# SADDLEHORN RANCH FILING NO.3

PCD FILE: SF-23-004

# V3\_Final Plat Drawings.pdf Markup Summary

JOB NO. 25142.05  
JULY 19, 2023  
SHEET 3 OF 5

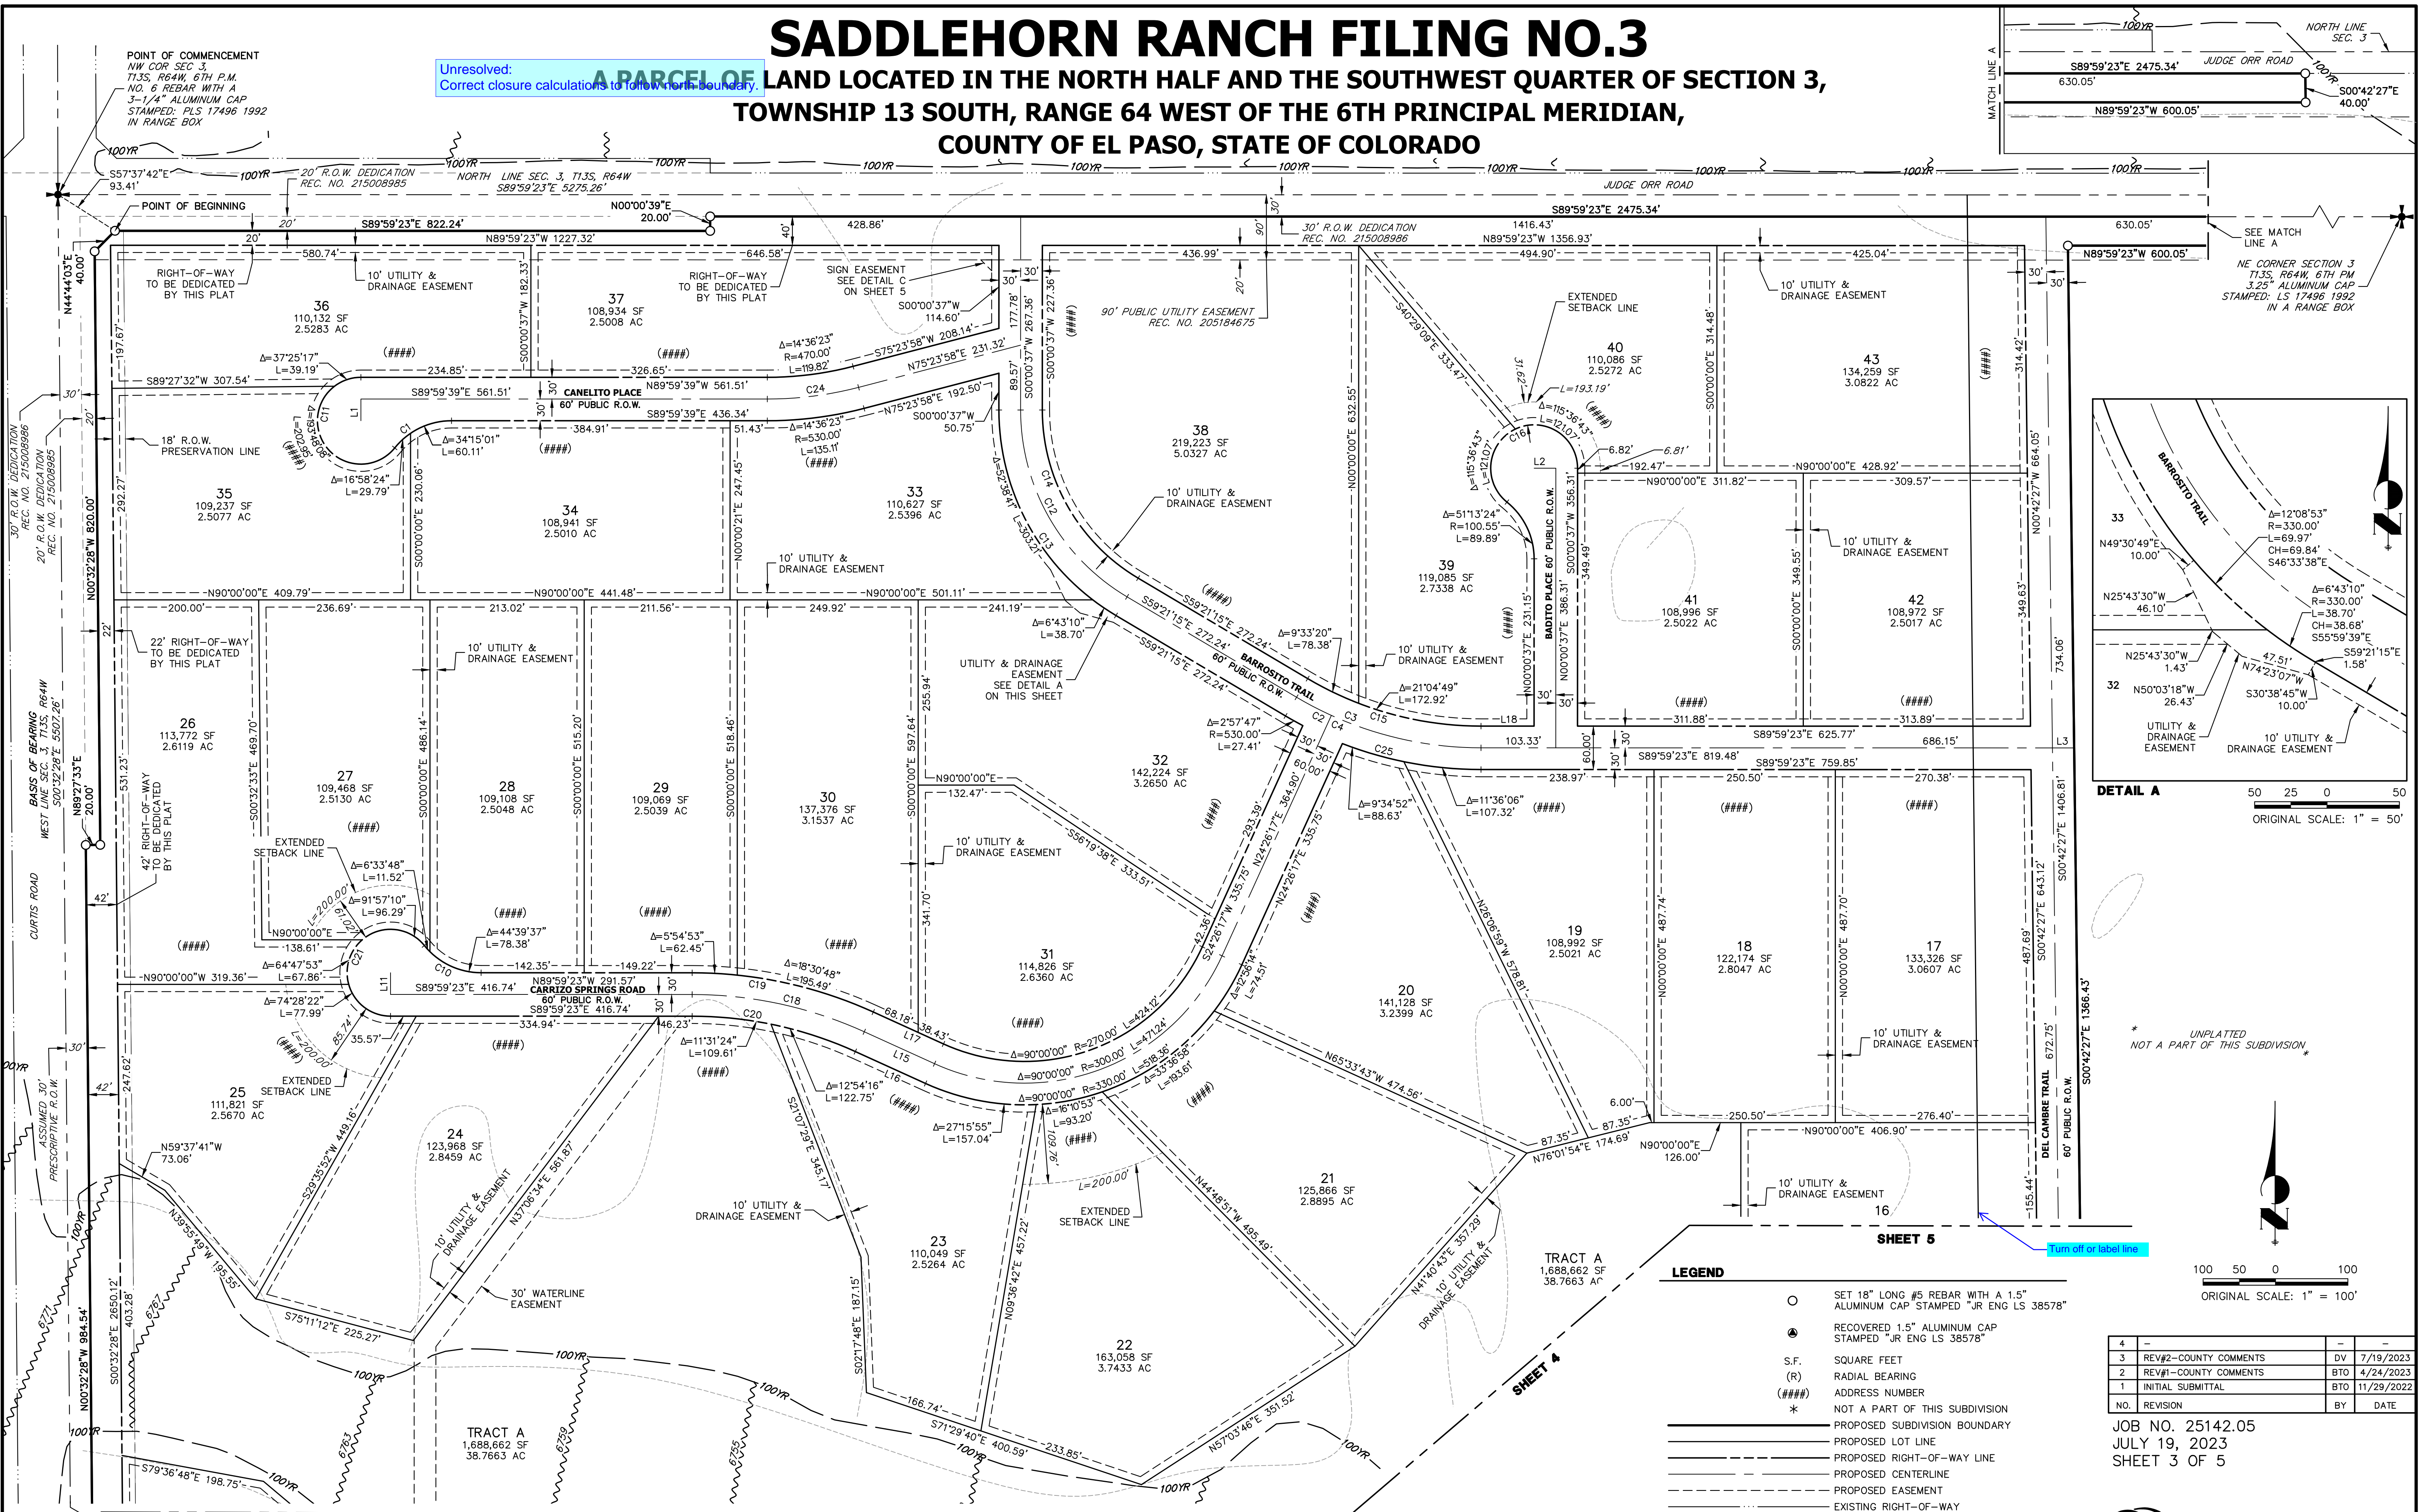
Unresolved: A PARCEL OF LAND LOCATED IN THE NORTH HALF AND THE SOUTHWEST QUARTER OF SECTION 3, TOWNSHIP 13 SOUTH, RANGE 64 WEST OF THE 6TH PRINCIPAL MERIDIAN, COUNTY OF EL PASO, STATE OF COLORADO

Turn off or label line

Unresolved:  
Correct closure calculations to follow north boundary.

JOB NO. 25142.05  
JULY 19, 2023  
SHEET 4 OF 5

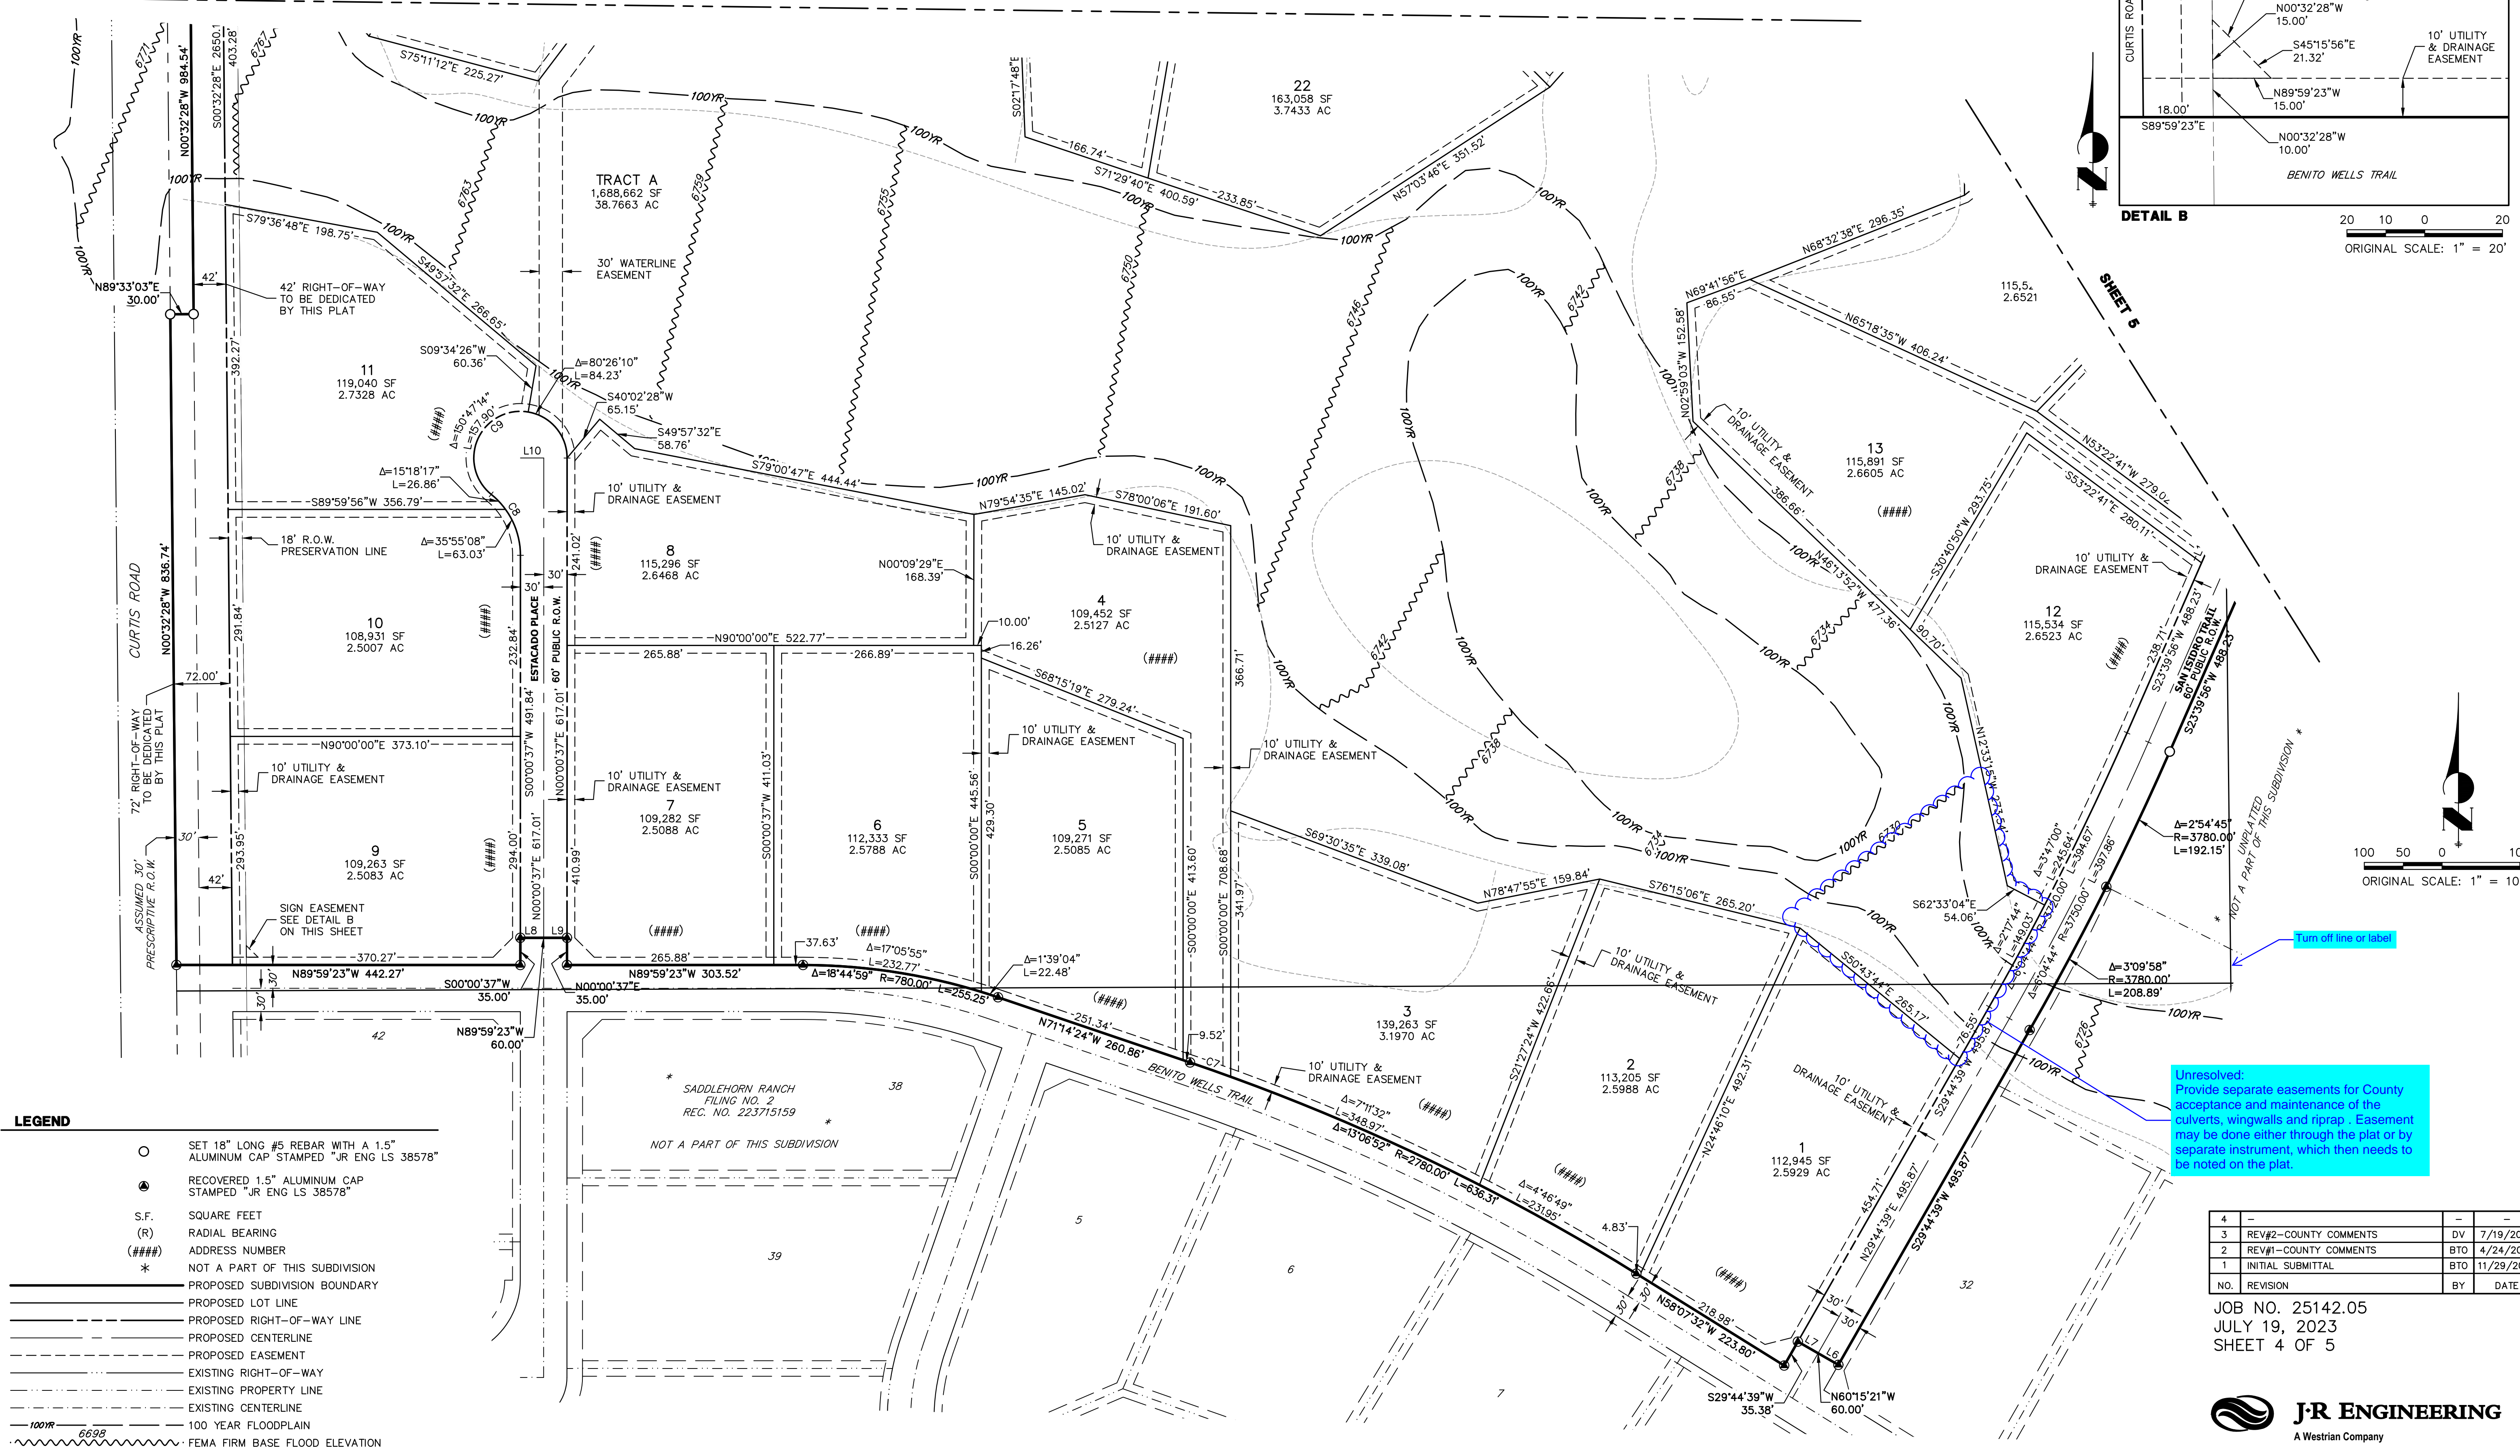
Unresolved:  
Provide separate easements for County acceptance and maintenance of the culverts, wingwalls and riprap. Easement may be done either through the plat or by separate instrument, which then needs to be noted on the plat.

Turn off line or label

Unresolved:  
Provide separate easements for County acceptance and maintenance of the culverts, wingwalls and riprap . Easement may be done either through the plat or by separate instrument, which then needs to be noted on the plat.
